SUBJECT: DSP#2002-0022 TUSCANY AT LANDMARK

Docket Item #3
DEVELOPMENT SITE PLAN #2002-0022
TUSCANY CONDOMINIUMS-YOAKUM PARKWAY

Planning Commission Meeting
October 5, 2004

ISSUE: Consideration of a request for a development site plan for construction of a multi-family residential condominium development.

Tandem Spaces in Gray

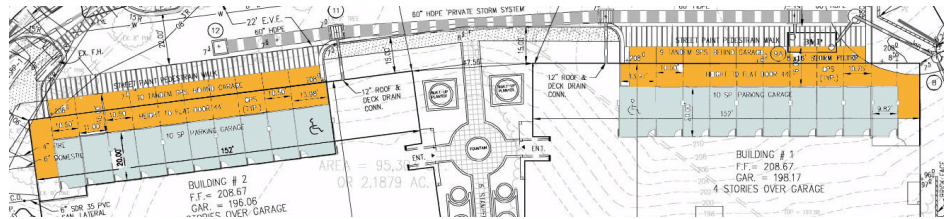
Staff’s primary concern remains with the inadequacy of proposed parking and the potential impacts of overflow parking onto adjoining properties as well as within the site. Staff is concerned that visitors will illegally park in the proposed drive aisle on the eastern portion of the site which also serves as an emergency vehicle easement. Topography limits fire truck access to the western (Yoakum Parkway) and the eastern portion of the building. Therefore, illegal visitor parking within the emergency vehicle easement will significantly impair the emergency and fire access to the building. In addition, residents would also likely illegally park on the adjoining Yoakum Parkway, impacting the traffic and vehicle safety of the adjoining streets. Compounding the concern regarding parking is the fact that 60% of the total proposed spaces are compact spaces (except for the tandem and handicap spaces).

Staff believes the arrangement of parking facilities on the site will, in fact, create a parking problem within the complex.

4. The applicant shall provide 15% visitor parking excluding tandem spaces. The location and design of the spaces shall be revised prior to the release of the final site plan to the satisfaction of the Director of P&Z. The applicant shall install "Visitor Parking Only" signs for all visitor parking spaces. A minimum of one space for each unit shall be provided within the garage as part of the purchase price for each unit. The underground parking shall have controlled access. (P&Z)(T&ES)(Police)
